COUNCIL ACTION FORM

SUBJECT: **REVISED MAJOR SITE DEVELOPMENT PLAN/PRELIMINARY PLAT
FOR SOMERSET SUBDIVISION**

Approved Somerset Plan

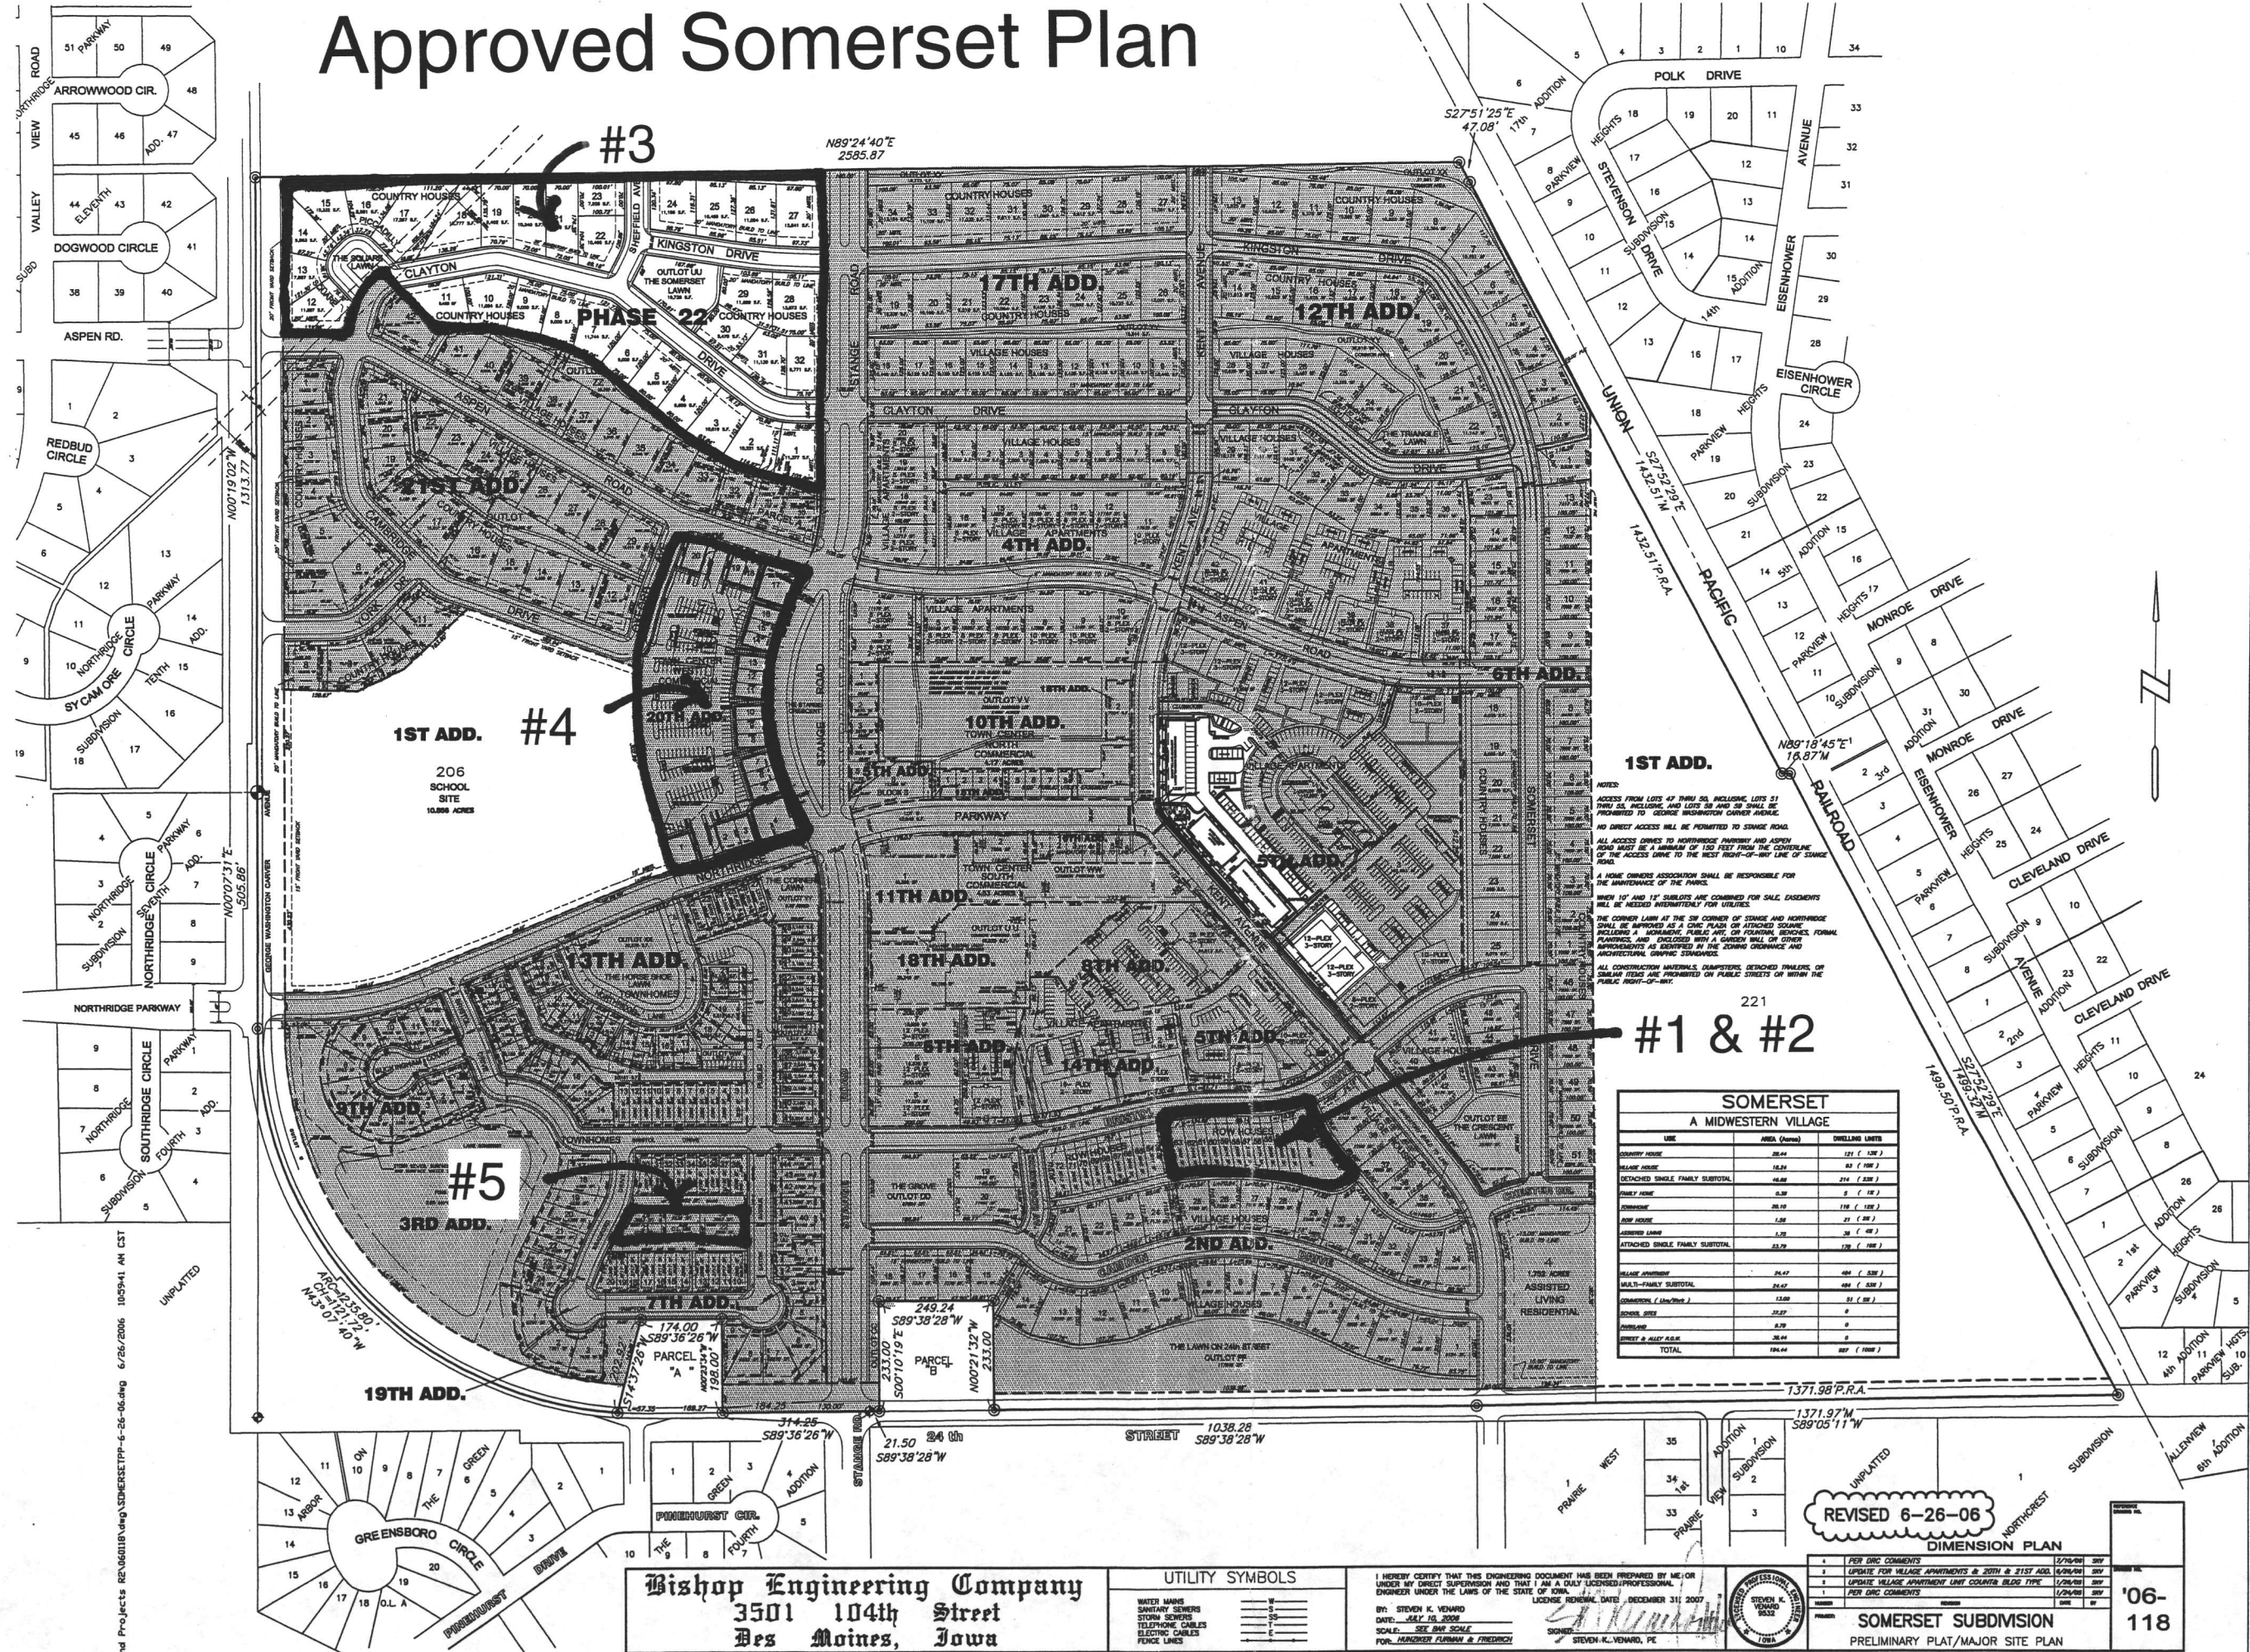
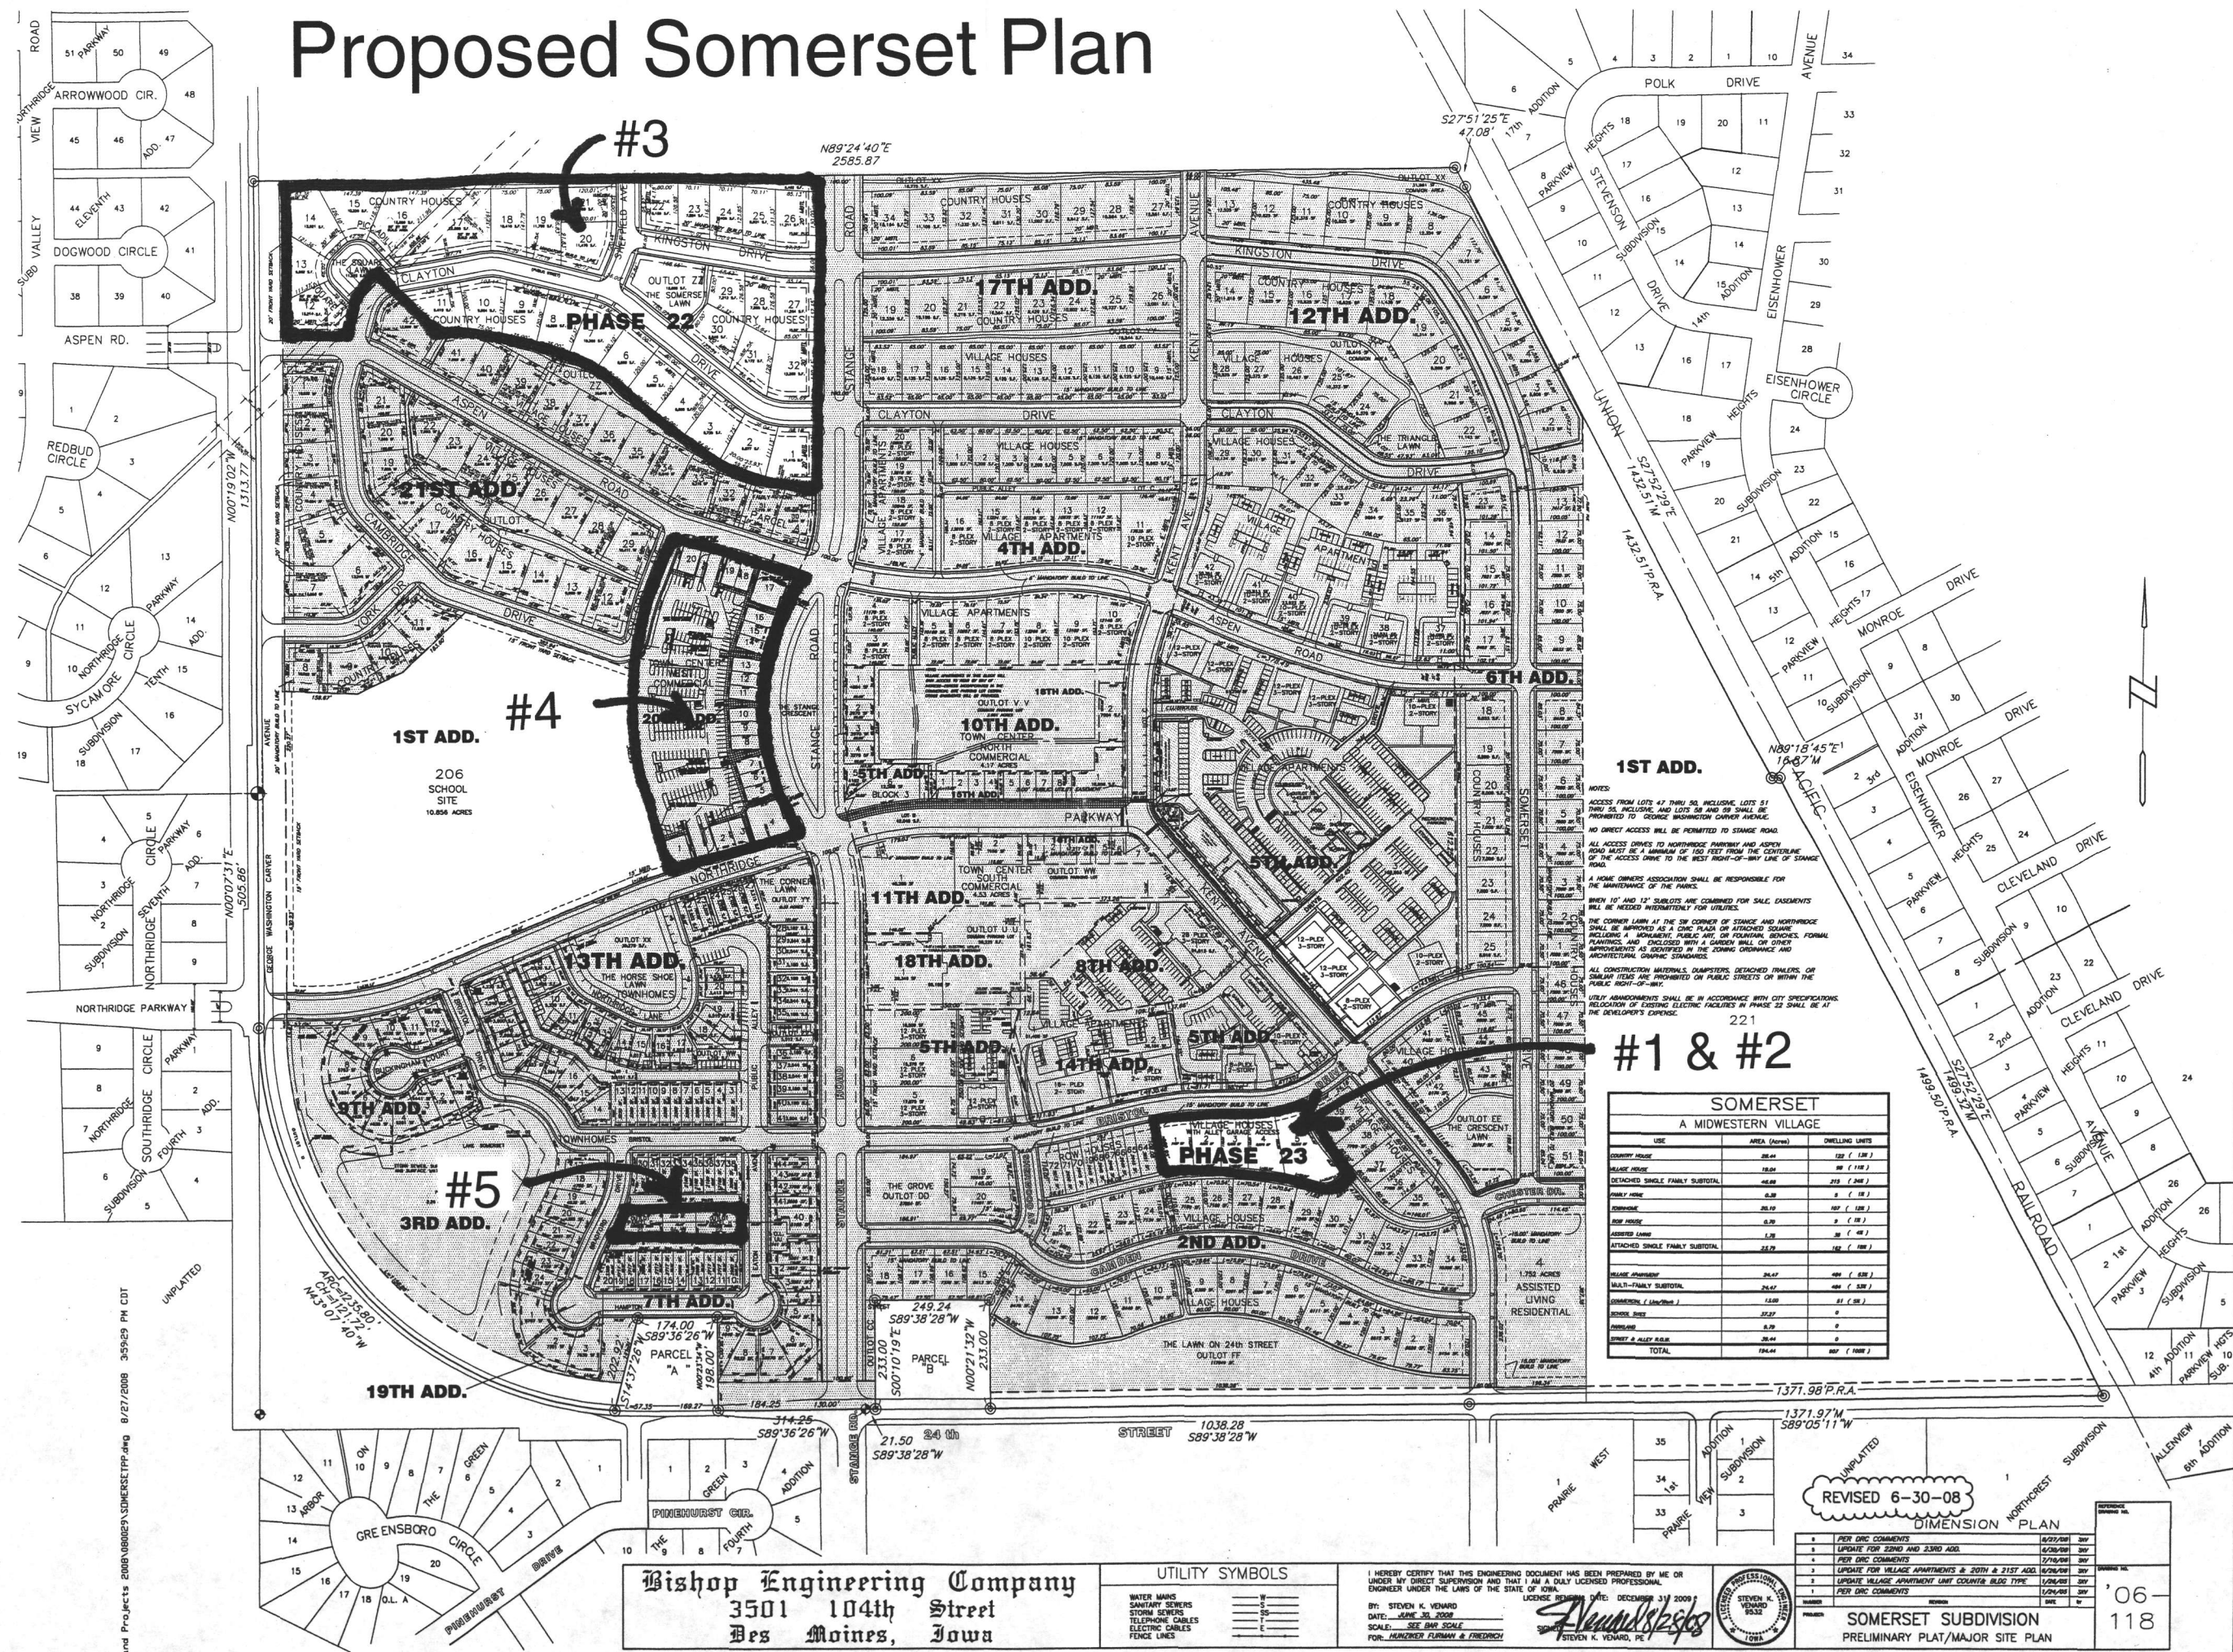
1. Change the type of housing planned for the lots along the south side of Bristol Drive, between the existing brick attached single-family dwellings (Row Houses) and the alley west of Kent Avenue from Row Houses to detached single-family dwellings (Village Houses). **See “#1 and #2” on the attached graphics of the “Approved Somerset Plan” and the “Proposed Somerset Plan.”**

2. Reduce the number of lots for the area of Somerset, described in #1 above, from 12 to 5. **See “#1 and #2” on the attached graphics.**
3. Change the dimensions of lots proposed in Phase 22 of Somerset Subdivision. **See “#3” on the attached graphics.**

4. Add a van-accessible parking space in the parking lot adjacent to the building at 2707 Stange Road. **See “#4” on the attached graphics.**
5. Change Lots 21, 22, 29 and 39 in Somerset Subdivision Seventh Addition between Bradford Drive and Eaton Avenue from lots planned for Townhomes to lots that will be open space landscaped lots. **See “#5” on the attached graphics.**

The response to the question of keeping the Row house planning or amend the planning for the construction of Village Houses was unanimous. Seven Association Board Members agree that the building of Village Houses in place of the Row house design would be acceptable, however, feel very strong about the need to address the snow removal problems which have become very apparent. The problem with small and large vehicle traffic through the alley, damage that has and continues to occur as vehicles leave the hard surface areas, and the issue of a dedicated place to locate plowed snow.

The alley problems are an issue that we feel the City of Ames and the Developers would want to address no matter which housing design is the final decision. Actual use of the alley has indicated a pattern of use by small and large vehicles. Snow removal becomes a significant problem which we have easily dealt with by using a small portion of the far east lot as a safe deposit point for the pushed snow.
